STATE OF MAINE
DEPARTMENT OF TRANSPORTATION
16 STATE HOUSE STATION
AUGUSTA, MAINE 04333-0016

December 19, 2024
Subject: Meadowbrook
Bridge Replacement
State WIN: 026442.00
Location: **Vassalboro**
Amendment No. 1

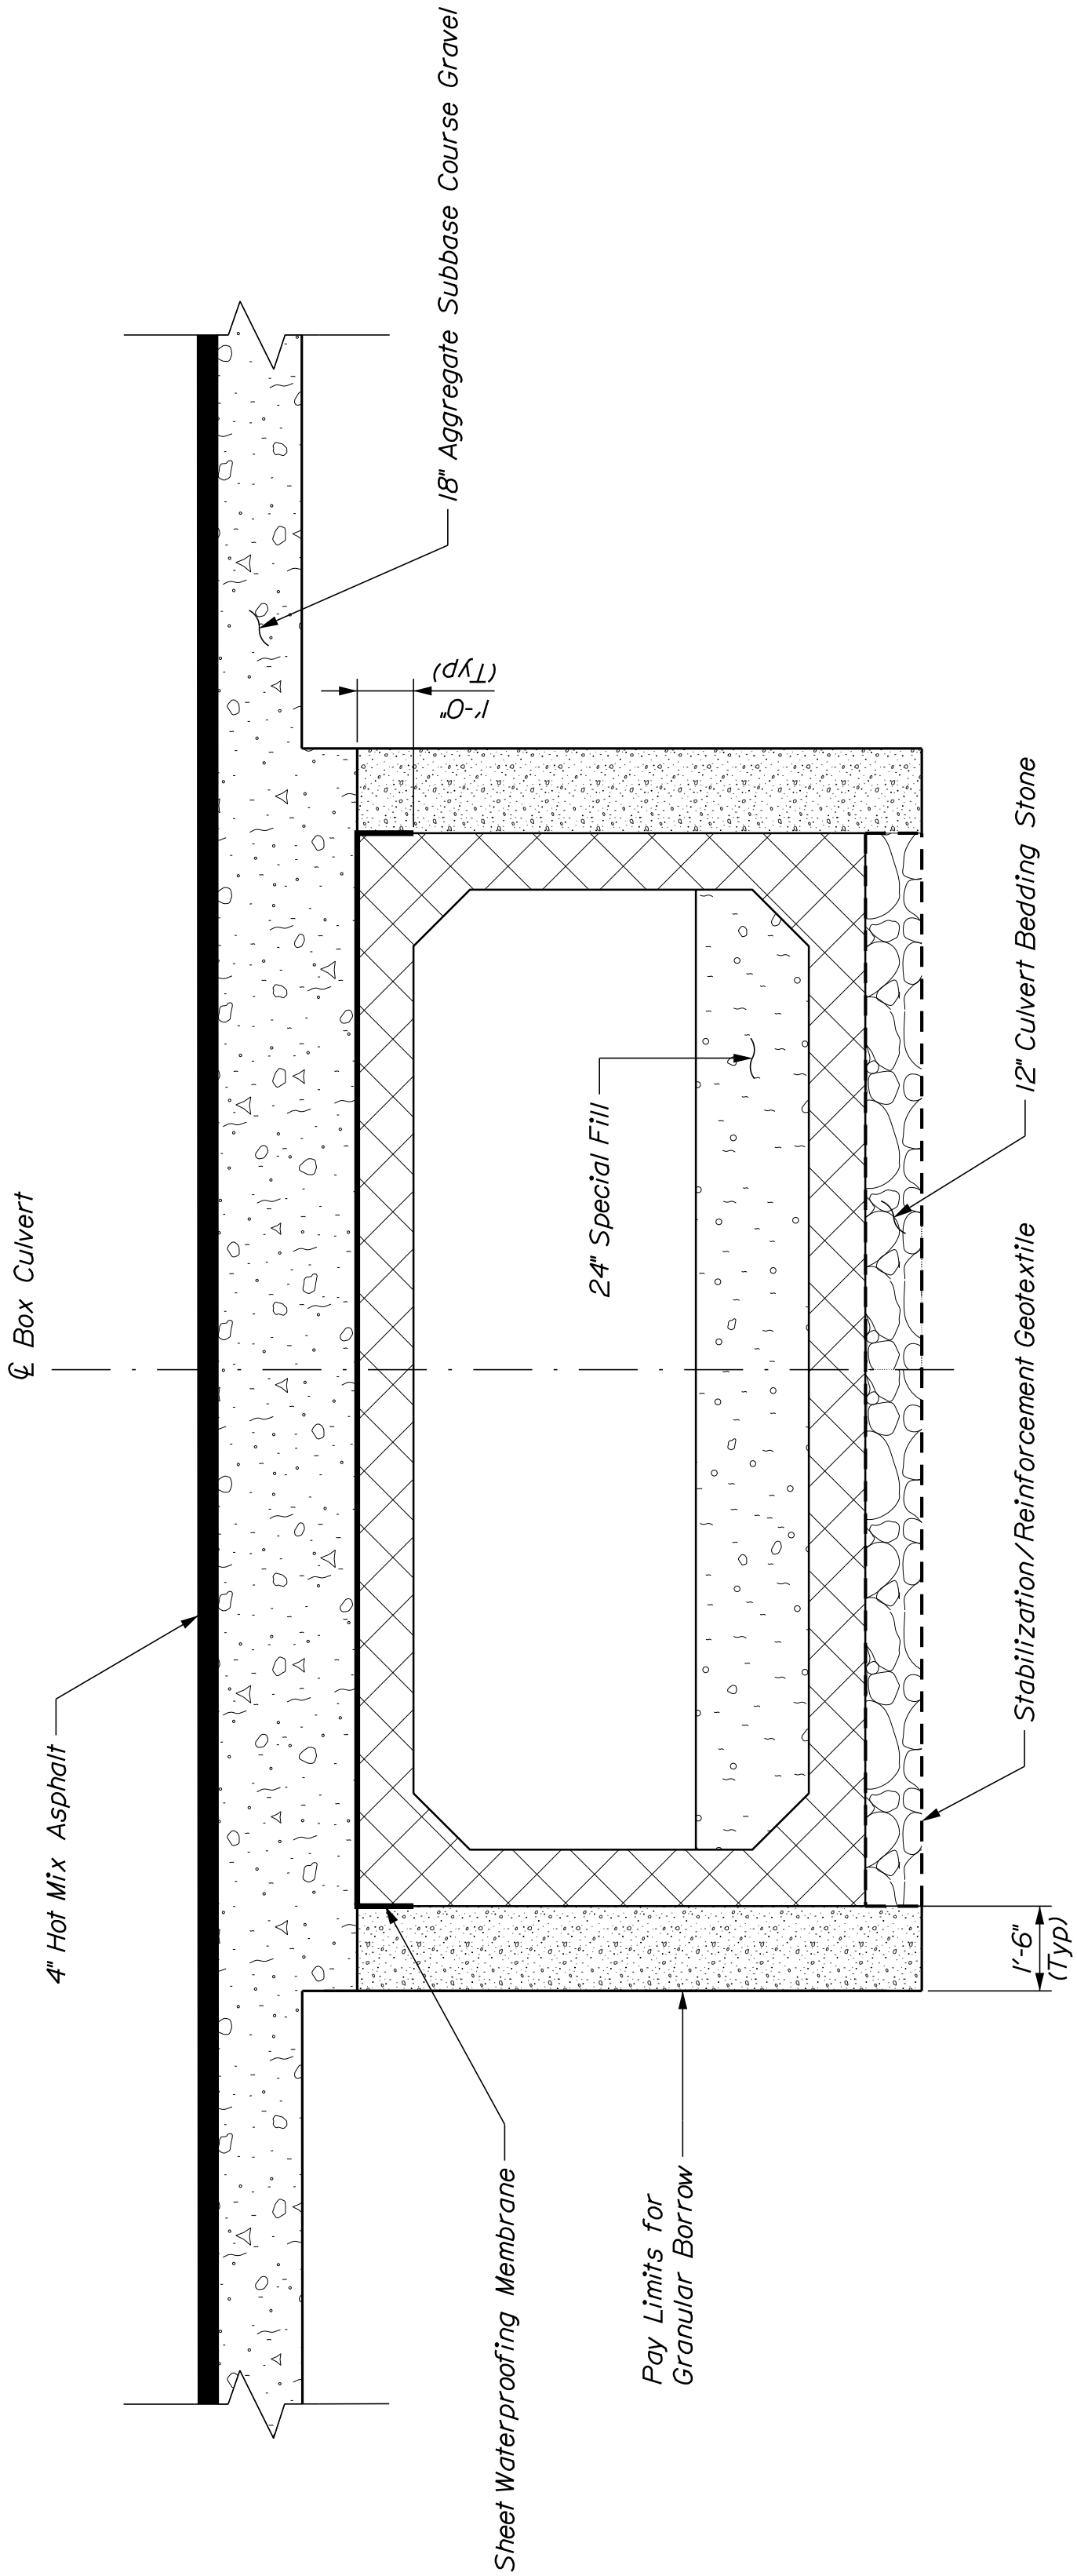
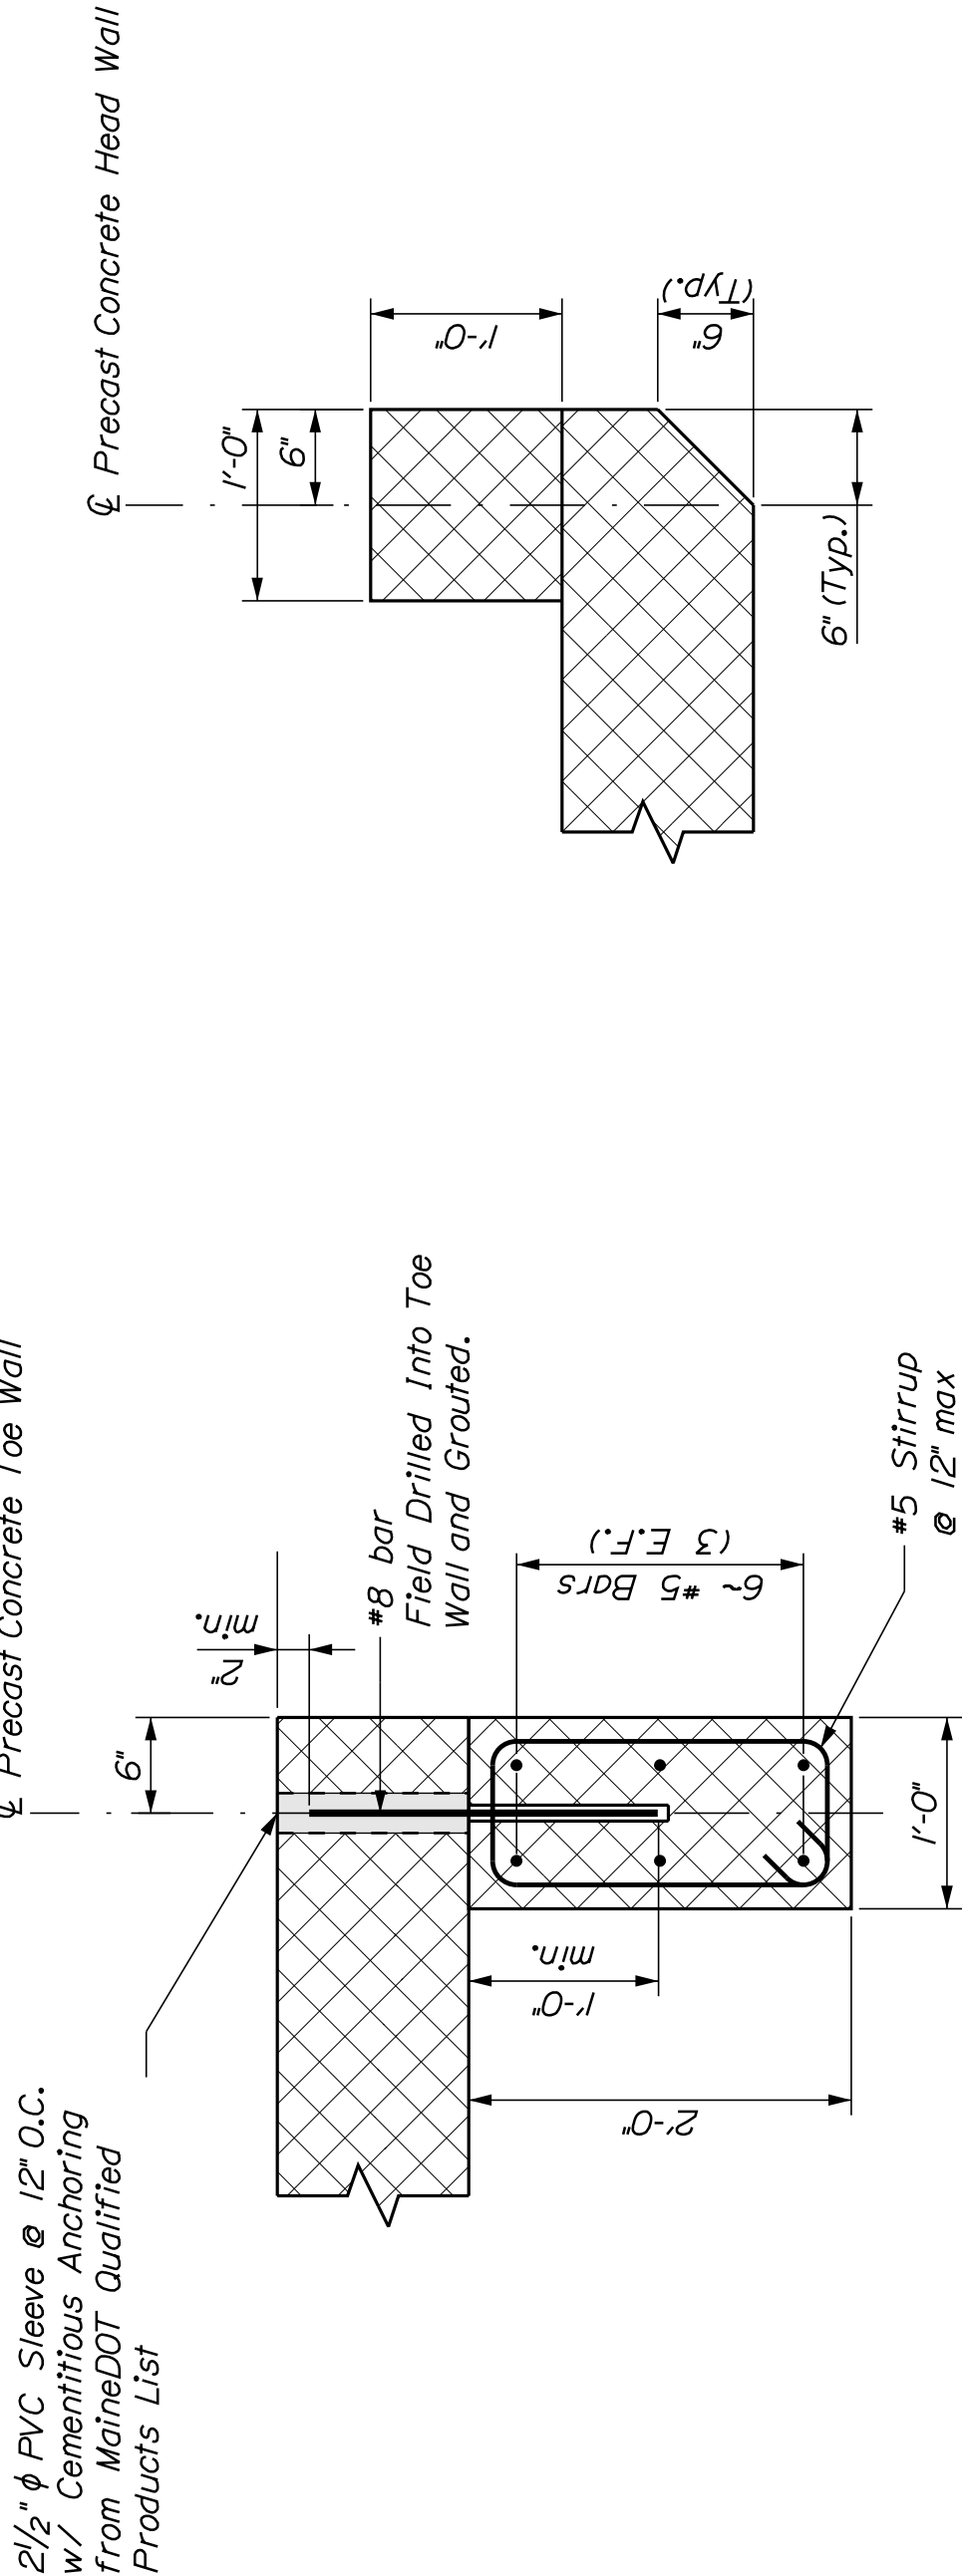
Remove sheet thirteen BOX CULVERT DETAILS (2 of 2) dated 11/20/2024 and Replace with the attached BOX CULVERT DETAILS (2 of 2) dated 12/16/2024
